**AUSTRALIAN NATIONAL COMMITTEE
ON LARGE DAMS**

GUIDELINES ON TAILINGS DAMS

Addendum

July 2019

“Figure 6 Flow sheet for seismic stability analysis

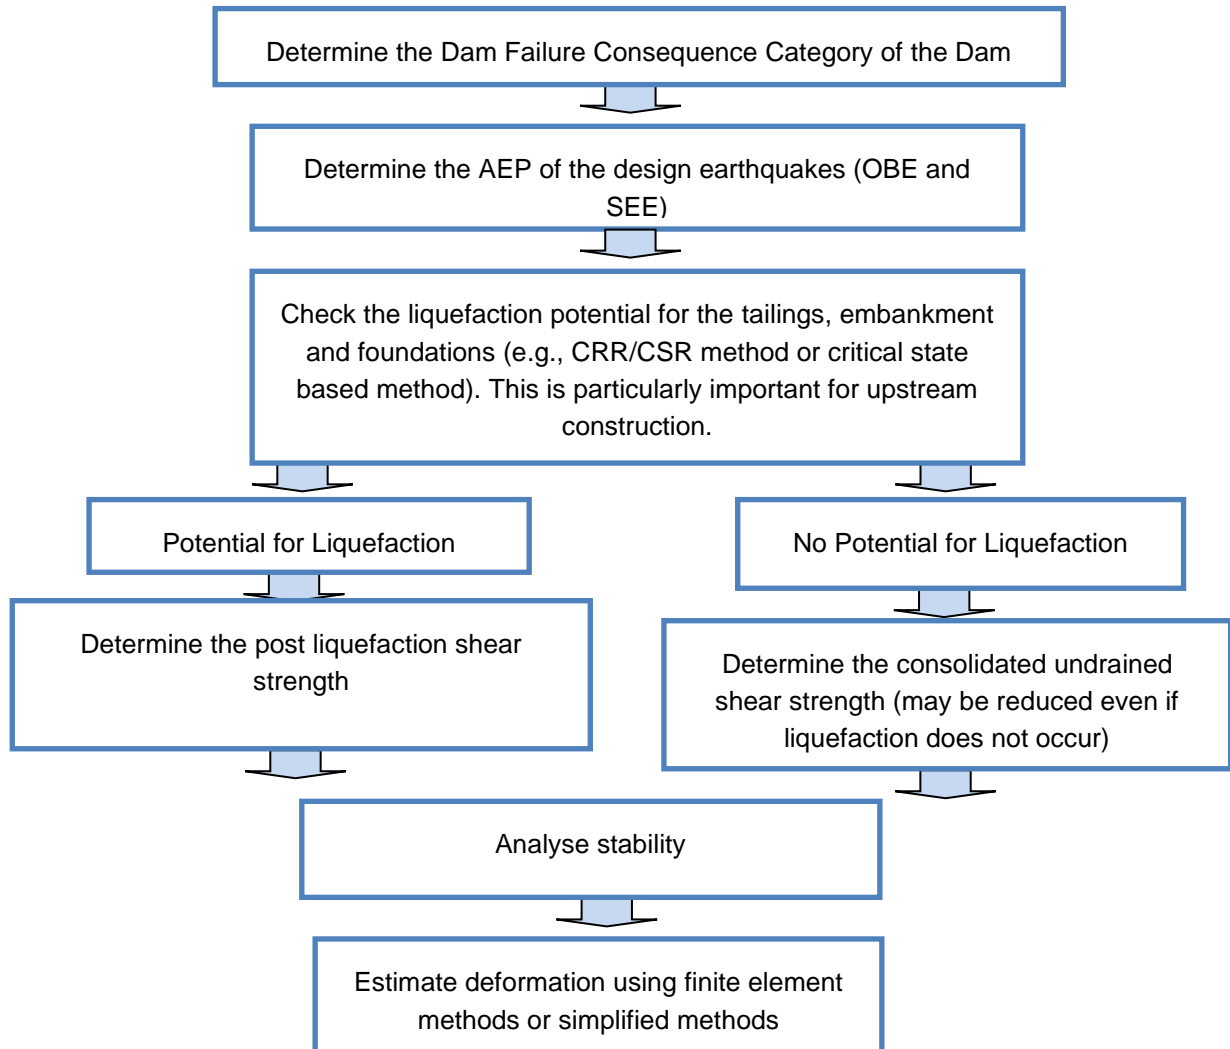
Page 46, Section 6.1.5.2 Replace Figure 6 with the following:
